Appendix D – Concept Plan MP 05_0062

Modification of Minister's Approval

Redevelopment of the Newcastle Hospital site for land uses being predominantly residential with ancillary non-residential uses such as retail and commercial uses; floor space ratio; building envelopes (footprints and heights); public domain improvements; vehicle access points; and site design principles for future project applications.

MP 05_0062 MOD 2: Modify the concept plan as follows:

NEWCASTLE ROYAL HOSPITAL SITE

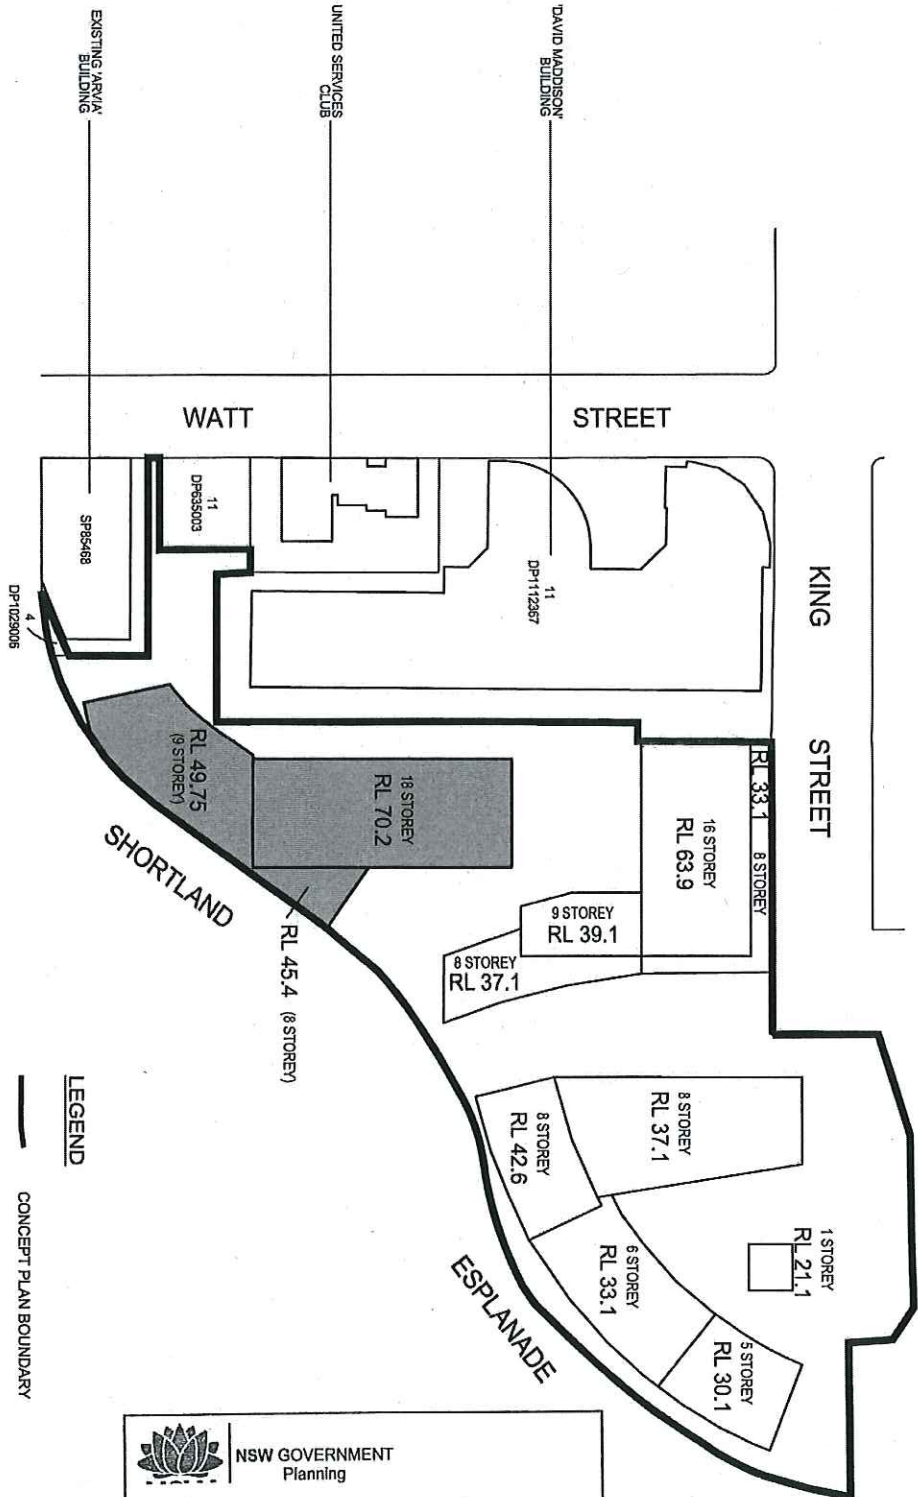
- excision of the David Maddison Building and the United Services Club car park site
- deletion of building envelopes on the excised sites
- modification of the building envelopes for Stage 1C
- inclusion of "hotel or motel accommodation" as defined in Schedule 2 an allowed land use within the concept plan.

Building Envelopes as shown as footprints and height drawing referenced 2922-CONCEPT AREA 29.10.12, titled *Newcastle Royal Hospital Site Plan Showing Proposed Concept Plan Area & Revised Building Envelopes*, prepared by de Witt

Consulting, dated 29.10.12 are maximum controls and to include articulation zones in accordance with the site design principles.

- a) Approved building heights are to be in accordance with the drawing referenced 2922-CONCEPT AREA 29.10.12, titled *Newcastle Royal Hospital Site Plan Showing Proposed Concept Plan Area & Revised Building Envelopes*, prepared by *de Witt Consulting*, dated 29.10.12.
- b) In addition, plant rooms, lift overruns and architectural roof features may occupy additional height as follows:
 - i. for buildings up to 25m, up to 3.0m in height; and
 - ii. for buildings over 25m, up to 5.8m in height.

- a) Delete 2.1 Built Form, a) Floor Space Ratio (FSR)
- b) Modify 2.1 Built Form, e) Building setbacks to identify a setback of a minimum 3 metres to the kerb for Stage 1C the site design principle to replace the 2.5 metre minimum setback.
- c) Insert 2.1 Built-Form, g) View Sharing
